RE: McGill Permit Modification SWC 19-06

MCGILL ENVIRONMENTAL SYSTEMS

CHATHAM COUNTY FACILITY

COMPOSTING FACILITY PROPOSED MODIFICATIONS

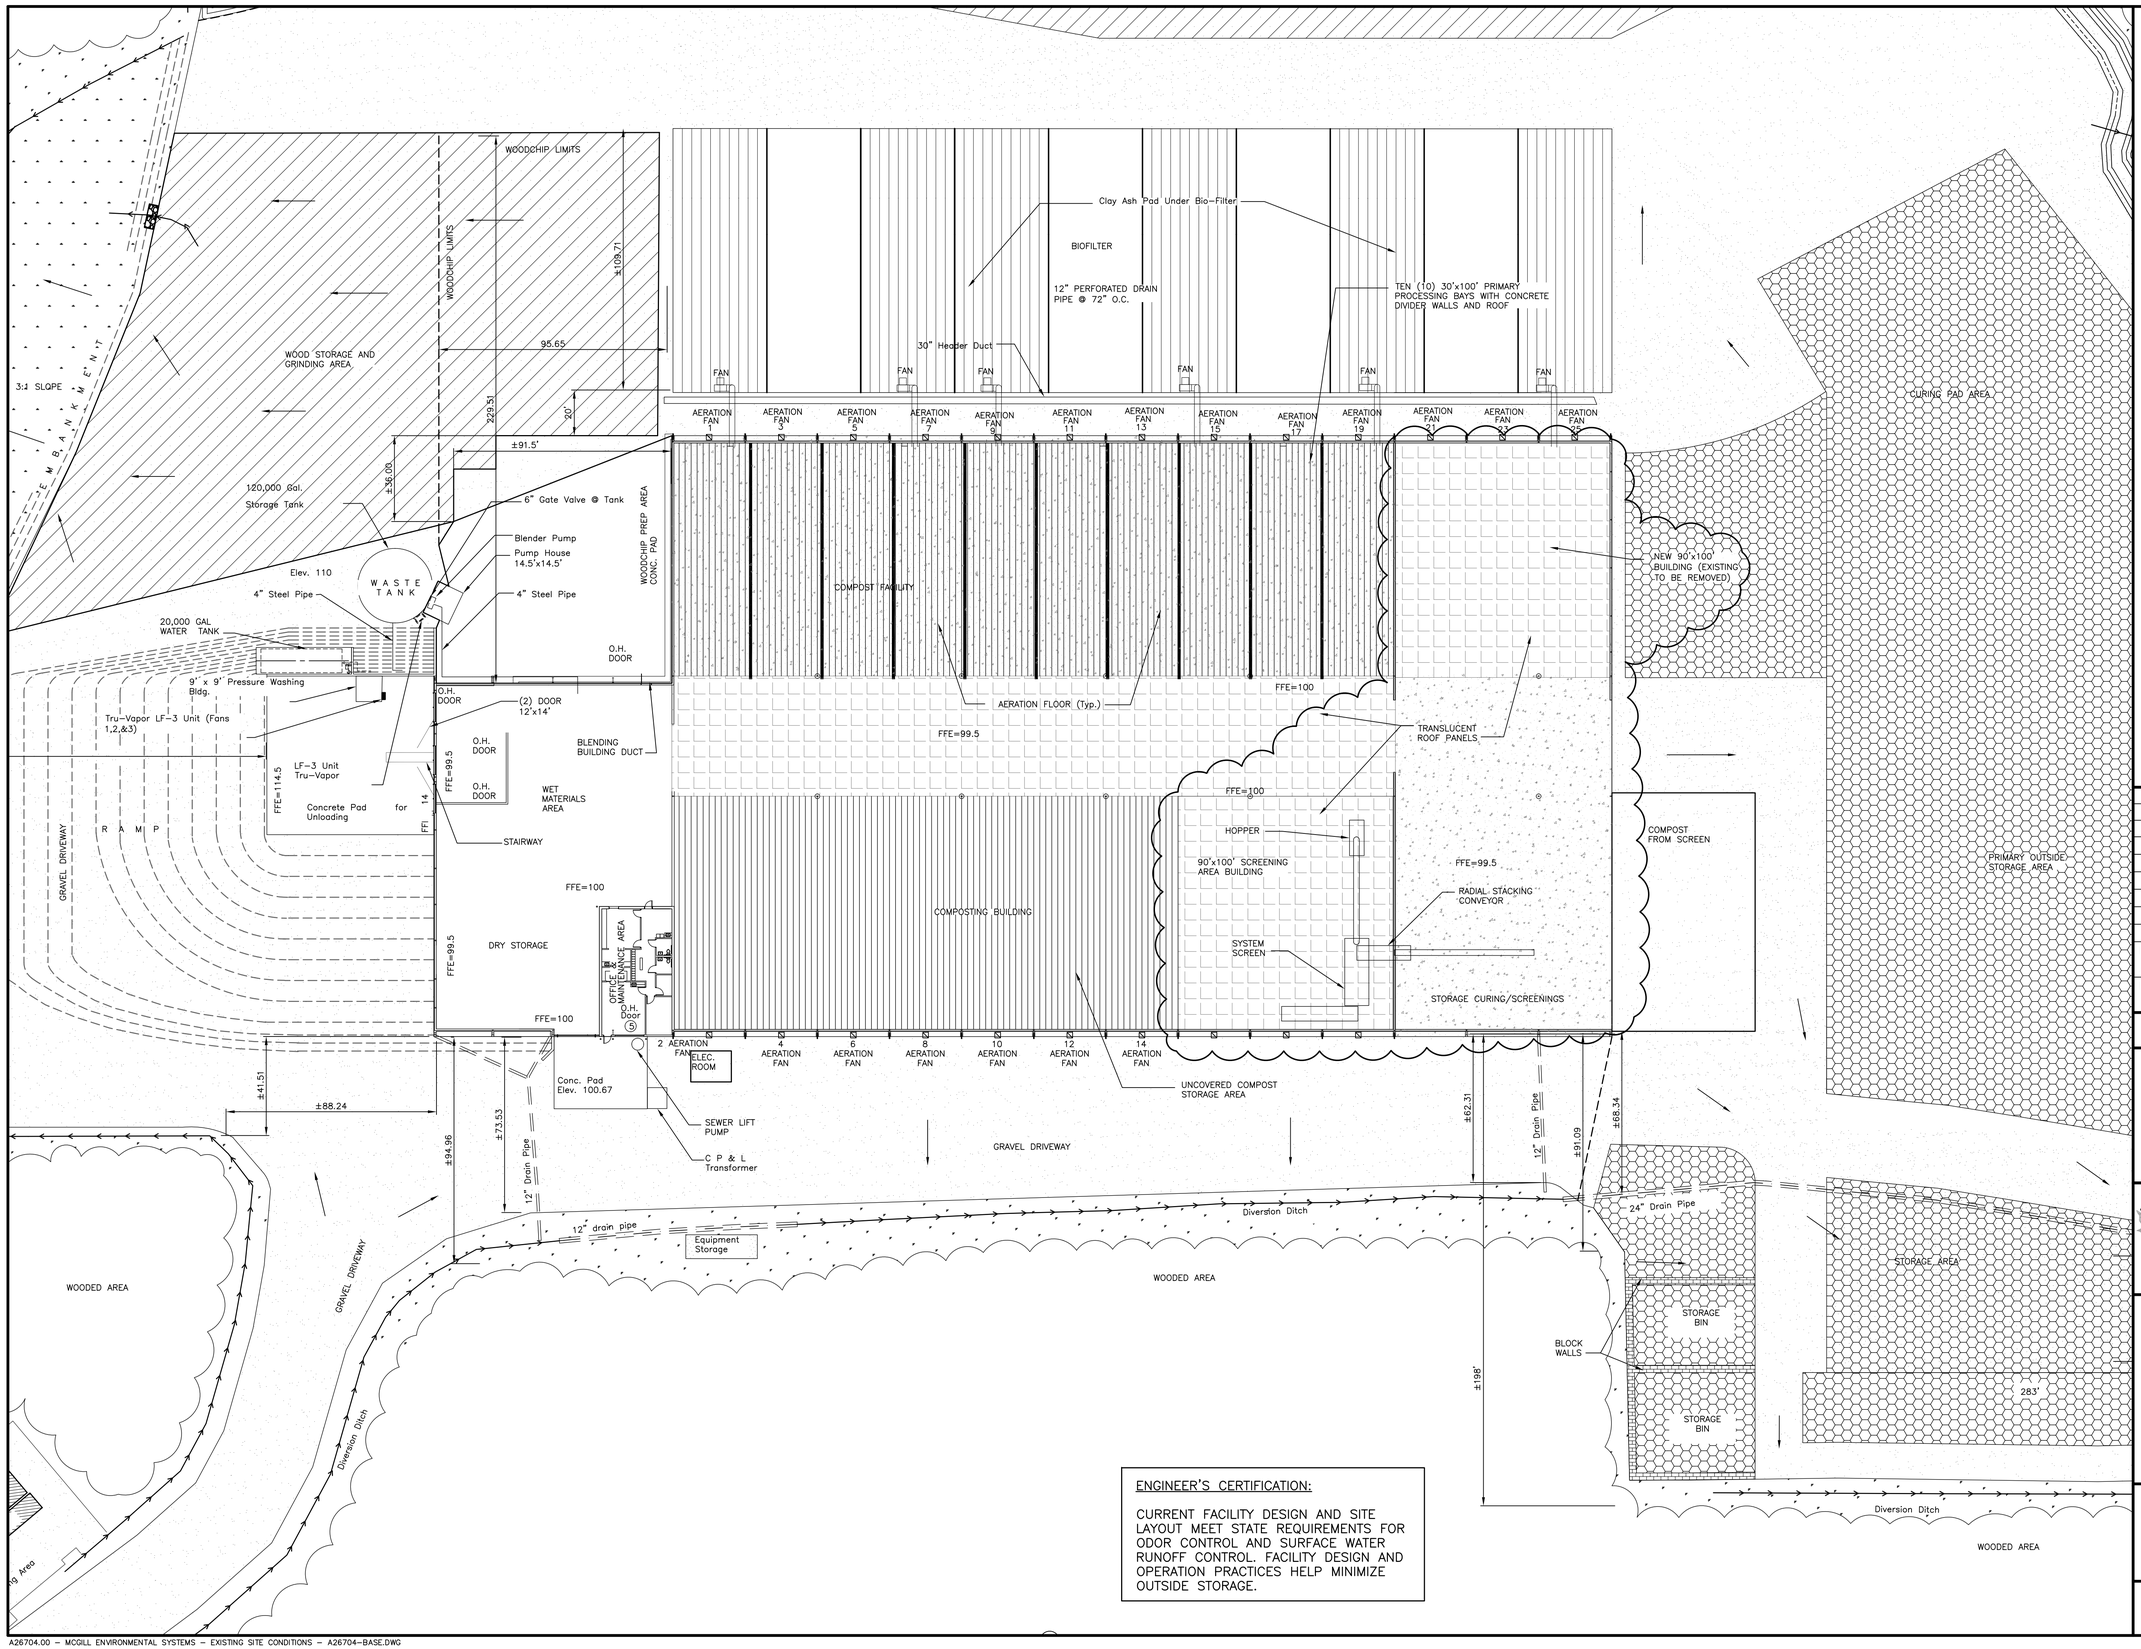
- Replace the existing portable Doppstadt screen with a stationary Liwell deck screen with stacking conveyer.
- Cover a 90’ by 100’ area opposite the processing bays in preparation for future location for inside screen.
- Install new inside screen in newly covered area. This will replace the existing trommel screen.
- Install fans with variable frequency drives in bays 2, 4, 6, 8, 10, 12, and 14. The purpose of this will be to further cure and dry compost and amendments. Dryer materials will greatly benefit the blending process and indeed the mix.
- Removal of the remainder of the old building. This is an open sided metal structure covering the curing bays 21, 23 and 25 and over the existing trommel

screening plant.

- Remove the old trommel screen, construct a new building over the curing bays 21, 23 and 25. This would take the same general shape as the portion of the old building covering these bays currently. It would however have a resolite roof and corrosion protection.

COMPOSTING FACILITY PROPOSED SITE PLAN

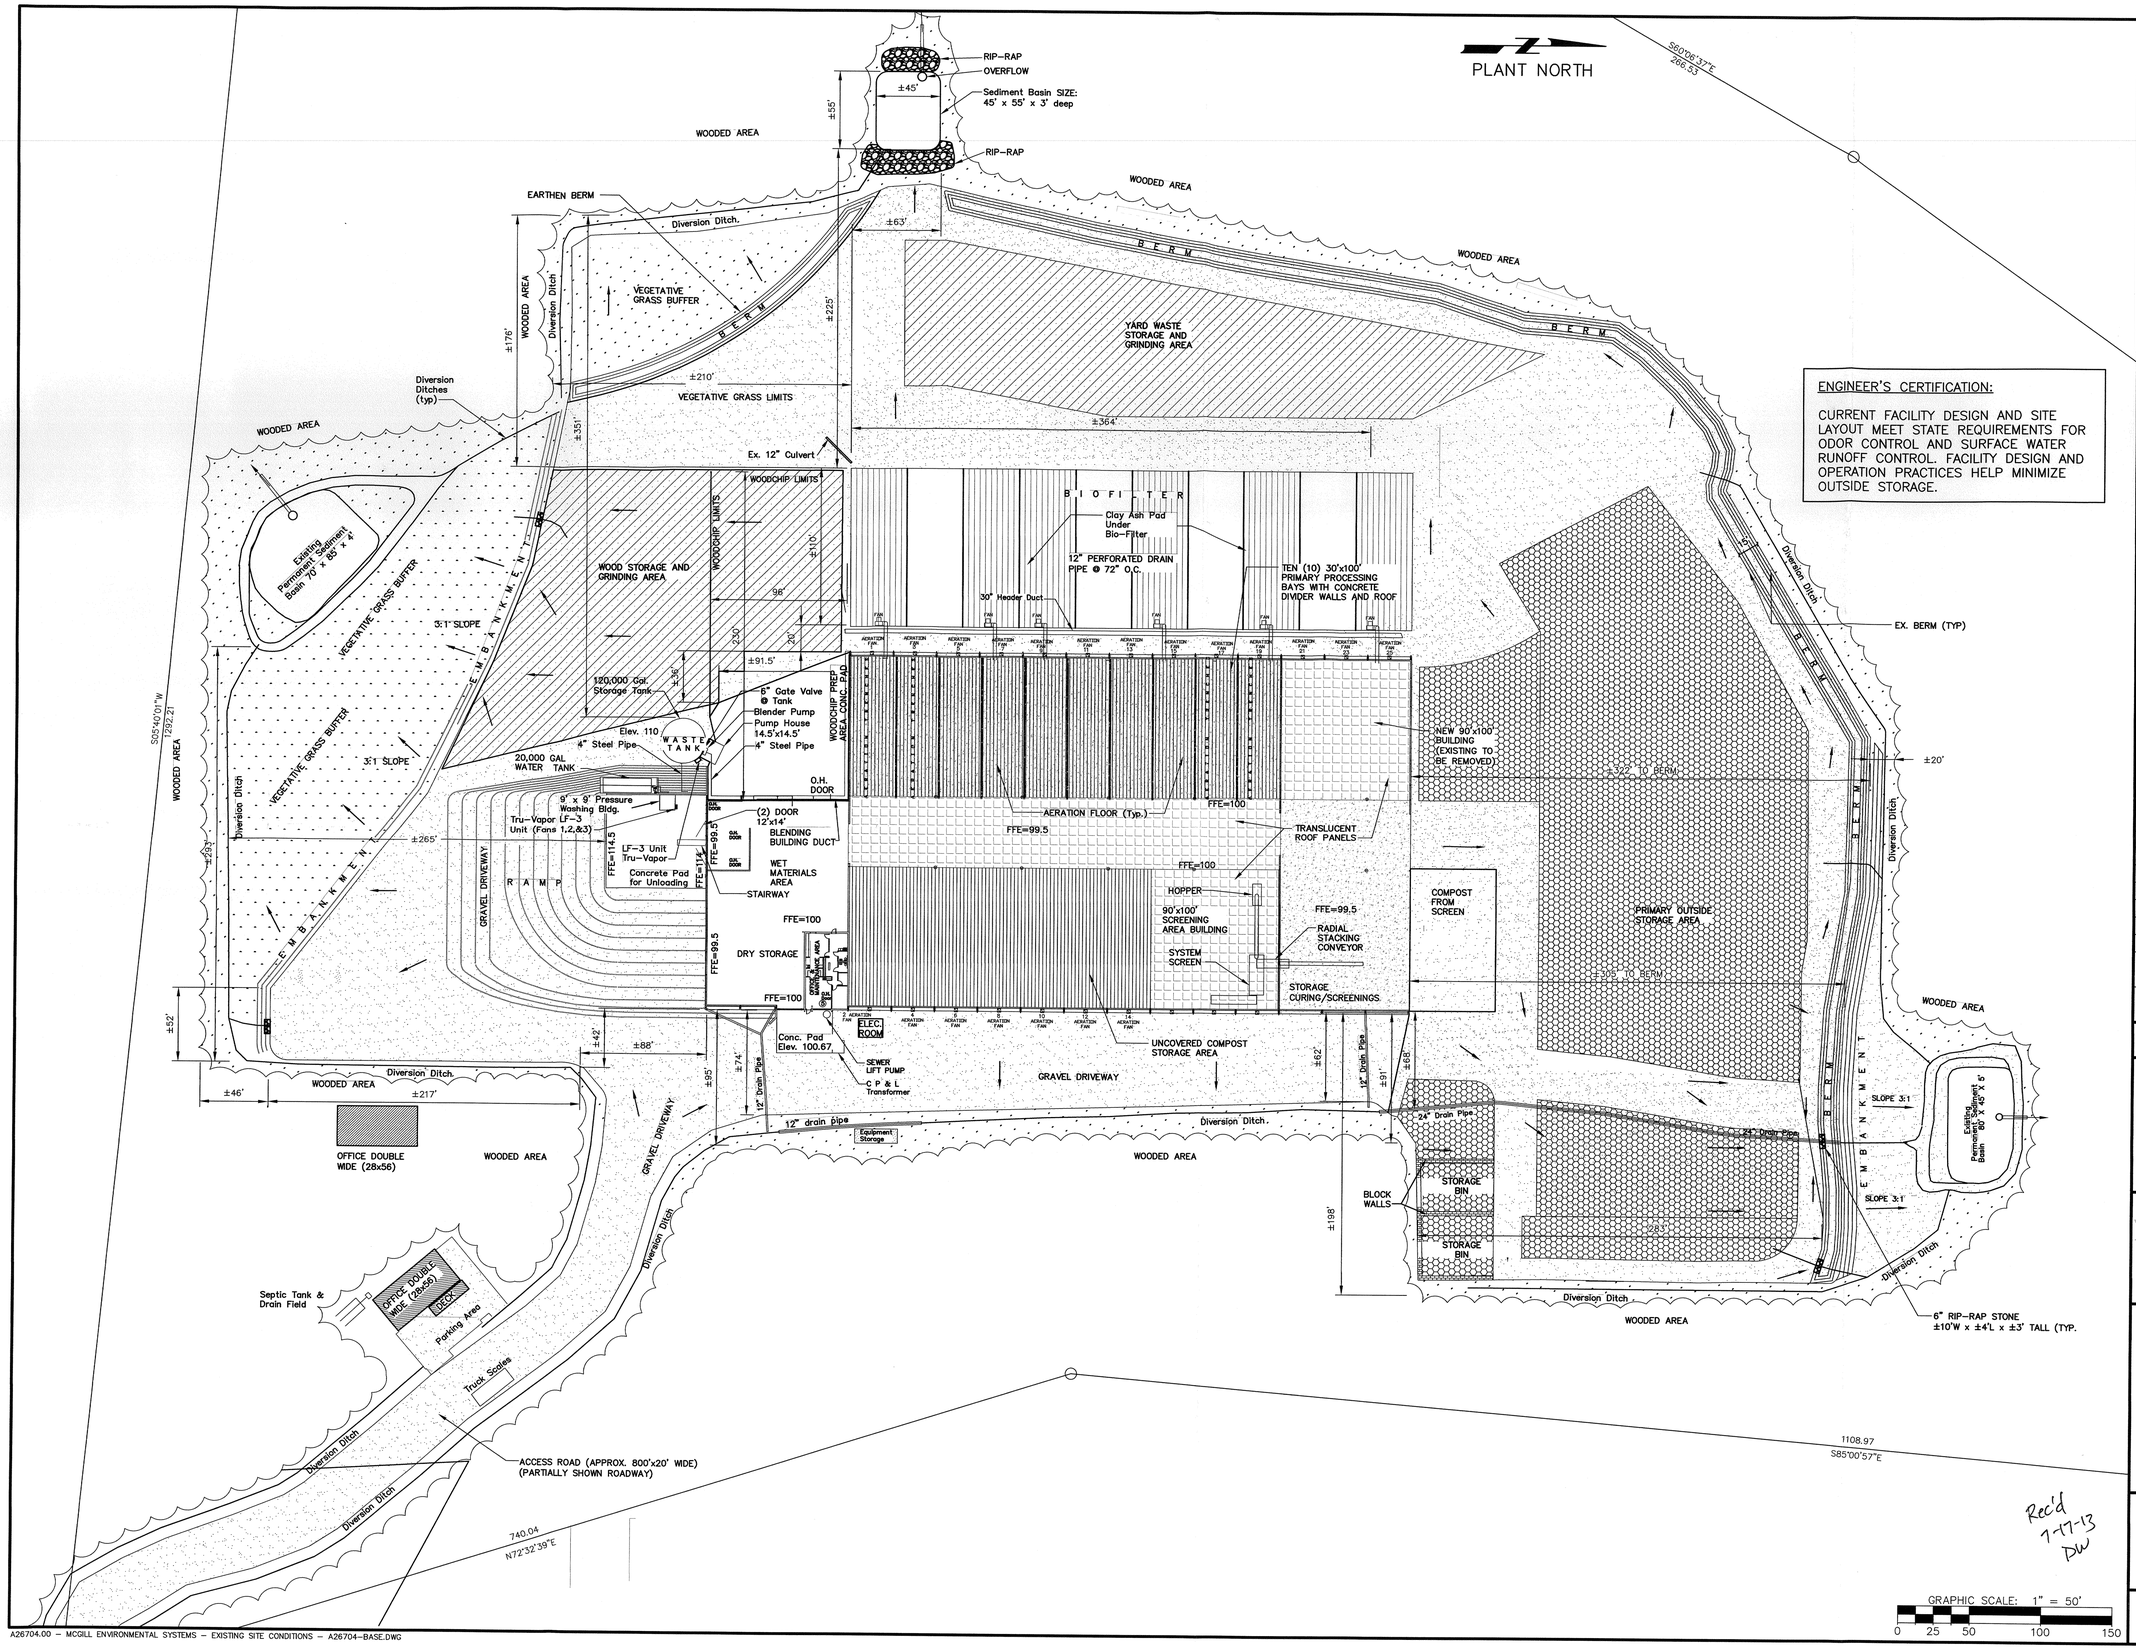
2) Footprint reduction. Compost coming from the screen will be pulled back inside the current screening area. This will result in a further tightening of the foot print of about 100' behind the building and a total footprint saving of 100'by 150'. (Attached drawing)
